Report on responses to questions from the Nunavut Water Board
in regards to the Water Reservoir, Sewage Lagoon and Landfill
Improvements for the Municipality of Qikiqtarjuaq, Nunavut

February, 2007

1.0 Introduction

Figure 1 Sensitivity Plots for Slope Stability

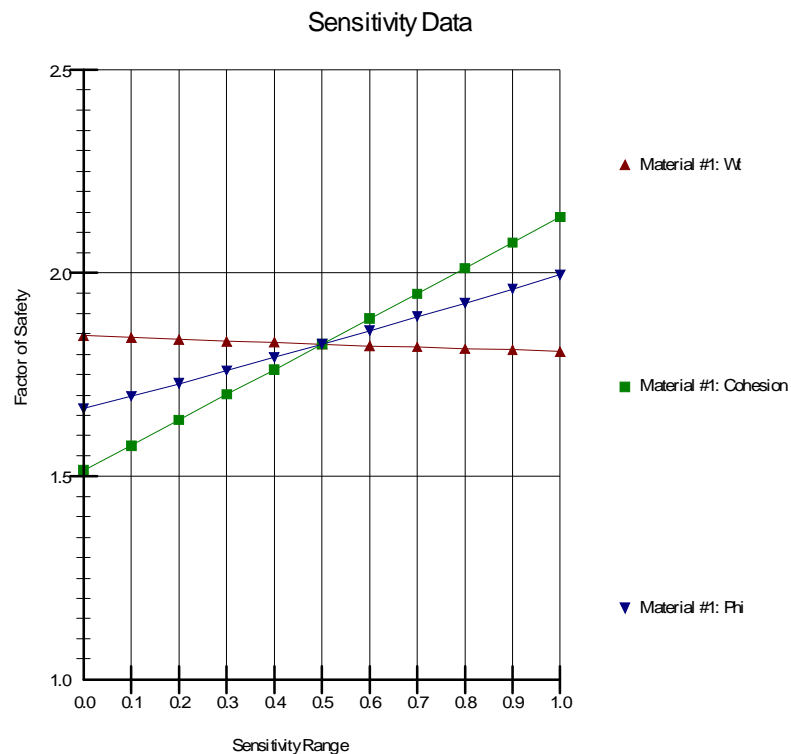
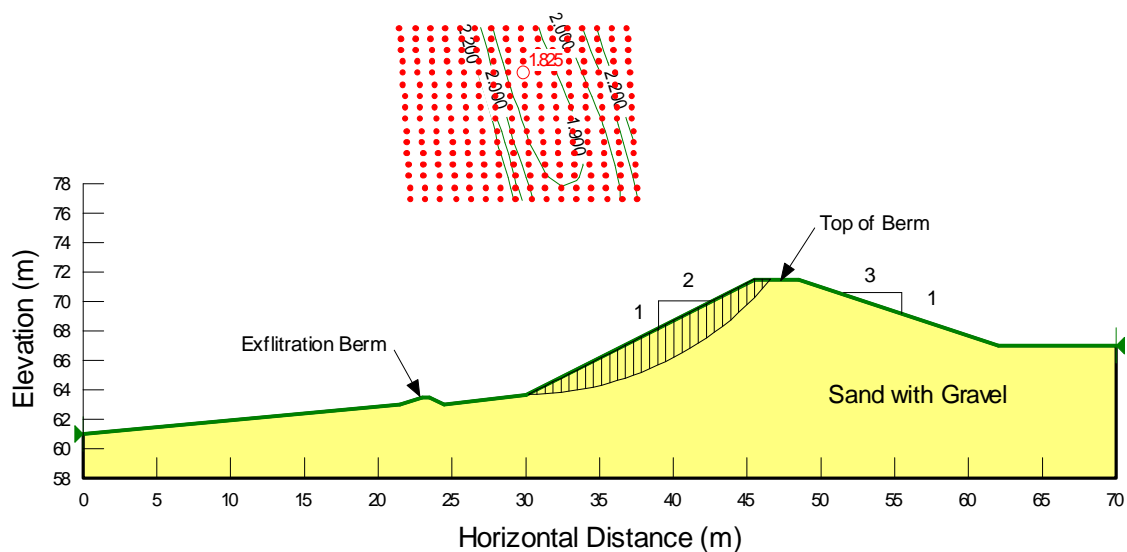
xiii The lagoon, landfill hazardous waste storage area and water reservoir each contain a perimeter berm in the design. Despite each structure containing a similar berm configuration the applied loadings for each structure may be unique. There is not a clear understanding of the stability of the perimeter berm from slope failure under the applied loads. Additional detail and discussion on the stability of the berms from slope failure are requested that provide a full description of:

(a) Method of analysis.

In order to determine the stability of the berm slopes for the proposed facilities, the most critical section is located at the downstream slope of the lagoon (Section B-B in design drawing No. 8). The upstream slope in this section is 3H:1V while the downstream slope is 2H:1V with a total slope height of approximately 8 m. The slope stability was assessed for the downstream slope of the lagoon berm because this slope is highest and steepest.

A potential failure surface with the lowest factor of safety was first determined by varying the radius of the slip circle and location of the failure axis associated with the mean values of the soil parameters (friction angle, cohesion and unit weight). The friction angle and unit weight were then held at the mean values, and safety factors were computed by varying the soil cohesion. This procedure was also used to assess the model sensitivity to the friction angle and unit weight while keeping other parameters at the mean values. The estimated mean values of the soil parameters and results of the analyses are summarized in Table 1.

Figure 1 presents the sensitivity plots. For presentation purpose, the strength and unit weight are normalized to a value ranging between 0 and 1. Zero means the lowest value in the range and 1 means the highest value. The point, where the three sensitivity lines are crossing, is the deterministic factor of safety, corresponding to mean values of the analyzed soil. Figure 1 indicates that the safety factor against slope failure, is higher than 1.5 for any combination of soil parameters. The safety factor of 1.5 is acceptable in geotechnical practice. Figure 2 illustrates the factor of safety for a 2H:1V slope and a potential failure surface generated with all input parameters set to the mean values.

Figure 4 Comparison of Gradations of In-situ Material to 25 mm minus Crushed Gravel

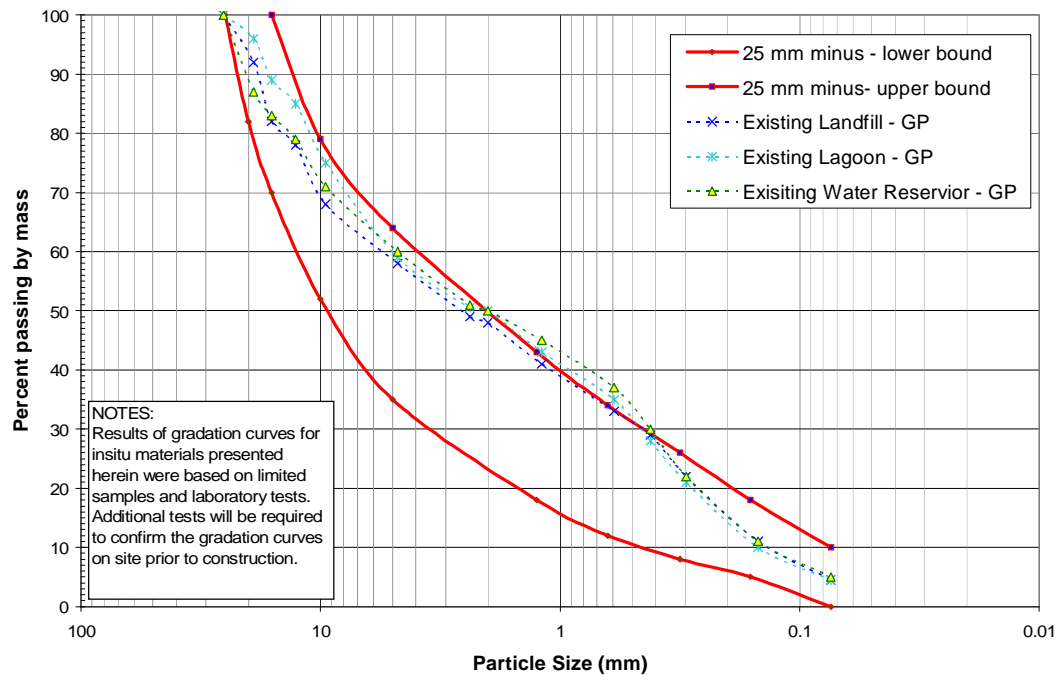
- b. A detailed monitoring plan, which includes, but not limited to, soil property testing methods (e.g., sieve density, moisture content, etc) and frequency of testing during construction is requested.*
- c. Detail and description into soil and material specifications acceptable for construction, as well as, specifications for as-placed conditions like moisture content, density, and standard proctor are also requested.*
- d. Will construction, quality assurance, and quality control monitoring be overseen by a qualified geotechnical engineer? If not, why not? How does the Proponent propose to report this information to the NWB?*

Sieve analyses were performed on selected samples by Alston Associates Inc. The results of all sieve analyses are presented in the Geotechnical Evaluation Report prepared by Nuna Burnside. The grain size distribution curves of these materials were then compared to upper and lower bound gradation envelopes for 25 mm minus gravel material typically used for foundation subgrade, embankment and road construction. The results of comparisons are presented in Figure 4. The solid lines, shown in Figure 4 demonstrate the upper and lower bound of gradation envelopes for the specified gravel material, and the dashed lines represent the gradations of the granular materials obtained in the test pits.

It was found that the particle size distribution, for the sampled materials, practically falls within the specification envelope for 25 mm minus gravel. The minor discrepancy of the grain size distribution within the particle size from 0.4 mm to 2 mm should not have a noticeable impact on performance of these materials as a material for berm construction if the gravel is properly compacted. Therefore, materials obtained from these sites are considered to be acceptable as a 25 mm minus gravel resource.

Figure 5 Total Pressure Head within Lagoon Berm due to Seepage

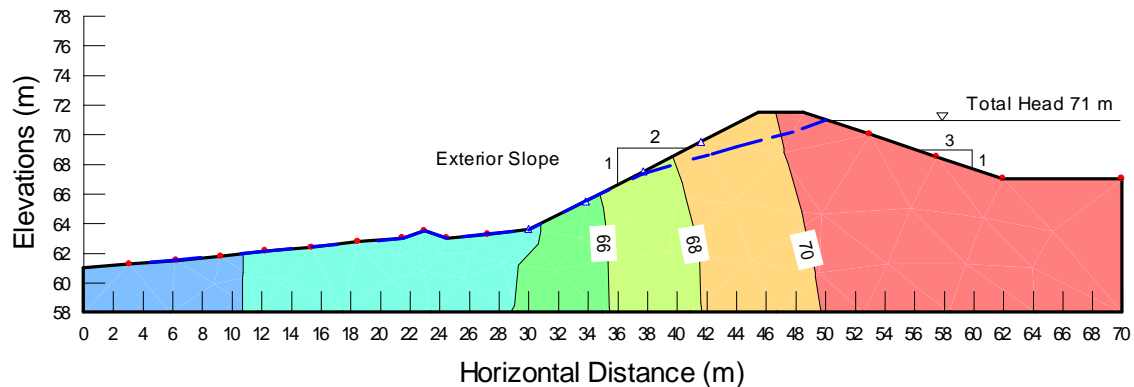
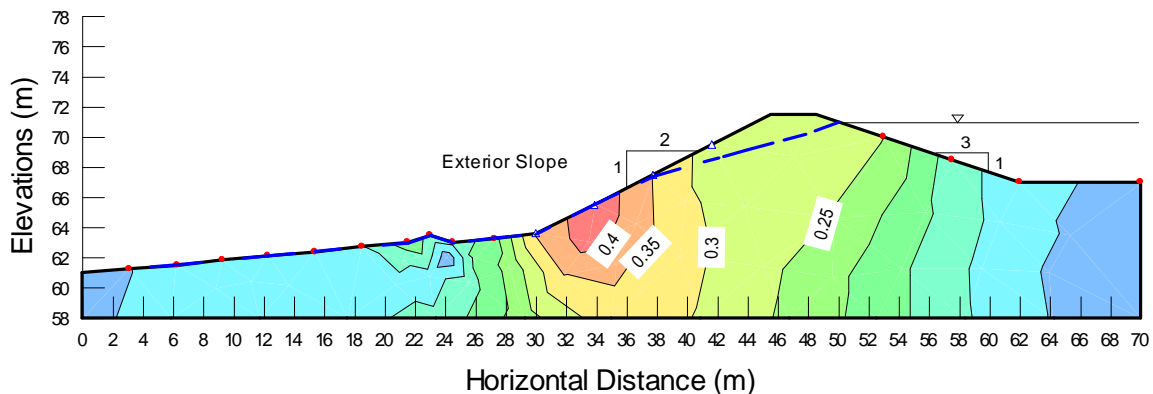
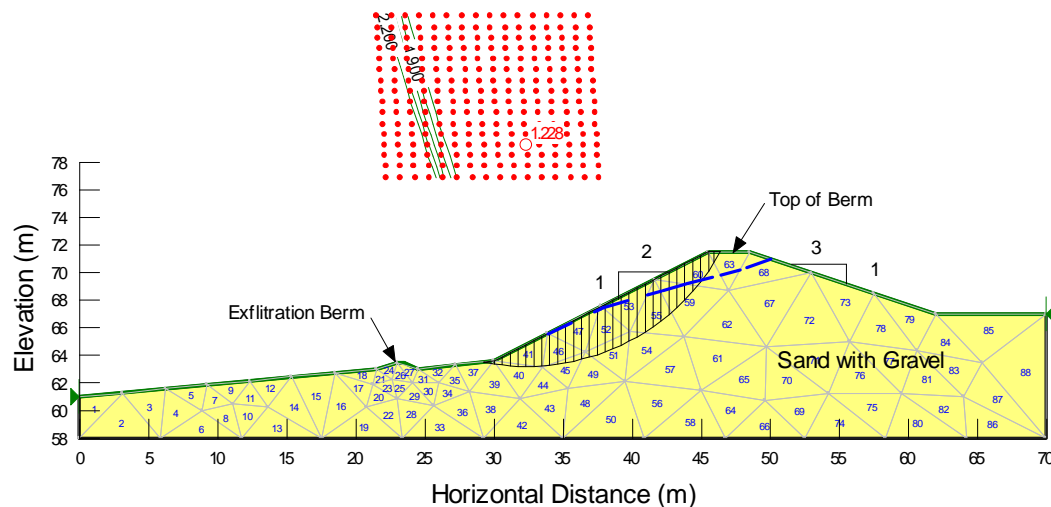
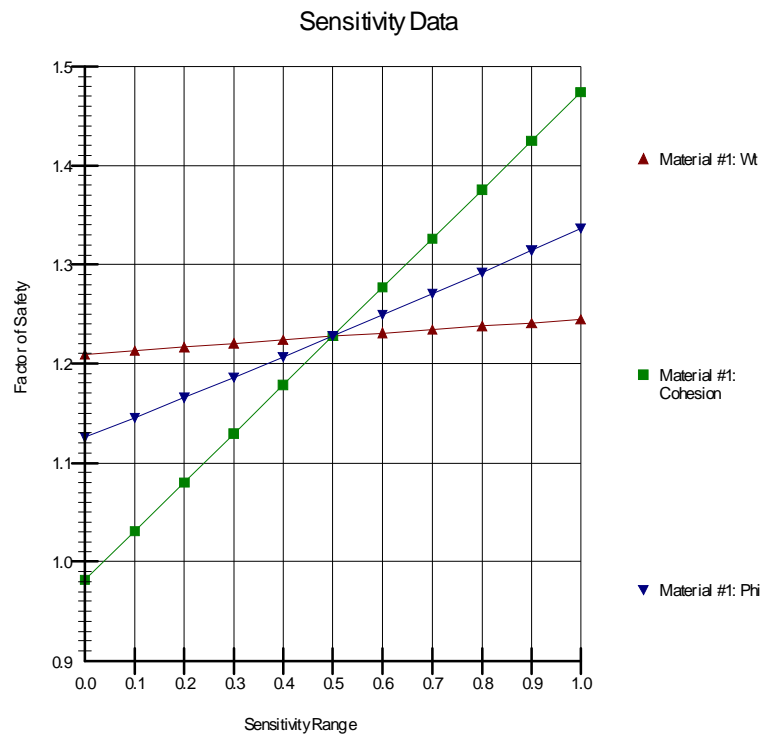
- iii *Has the potential for seepage through the landfill and lagoon berms and piping failure been considered in the design? If so, additional detail and discussion is required. If not, is the Proponent relying on permafrost aggregation into the berms.*

factor of 50%. It is understood that the K_{sat} has insignificant impact on the results of the seepage gradient. AMEC considers that this assumed parameter results in an adequate assessment of the seepage. Figure 5 presents the contour plot of total pressure head for the proposed berm under a steady flow condition. Figure 6 shows the contour plot of x-y gradient. It was found that the maximum gradient near the toe of downstream slope varies between 0.35 and 0.45.

The factor of safety against piping can be defined as the ratio of i_{cr} to i_{exit} where i_{cr} is the critical hydraulic gradient of berm material and i_{exit} is the estimated maximum gradient. The i_{cr} may be evaluated using void ratio (e) and specific gravity (G_s) of soil and generally varies within a range of about 0.85 and 1.1 (Das, 1983). The factor of safety against piping was calculated to be approximately 2, which is acceptable for short term period prior to the berm material being frozen.

As mentioned before, the pore water pressure within soil particles will reduce the effective overburden stress of the soil, and hence decrease the shear strength of the soil at the failure surface. The stability of berm slope was re-assessed by considering the pore water pressure within the berm due to seepage. The results of analyses, using mean value of soil parameters and the sensitivity plots are given in Figure 7 and Figure 8, respectively. The results indicated that the stability of berm slope is more sensitive to the cohesion of the compacted soil than other parameters. If the lower bound of this parameter was assumed, the factor of safety may decrease to less than unity. However, it is our experience that a mean value of cohesion shown in Table 1 should be warranted if the granular material for berm fill could be compacted to the specified density. Monitoring compaction during construction is required to ensure that the specified density is attained. Alternatively, if full time monitoring is not to be provided, it is recommended that a liner be installed on the inside slope of the downstream berm for the lagoon.
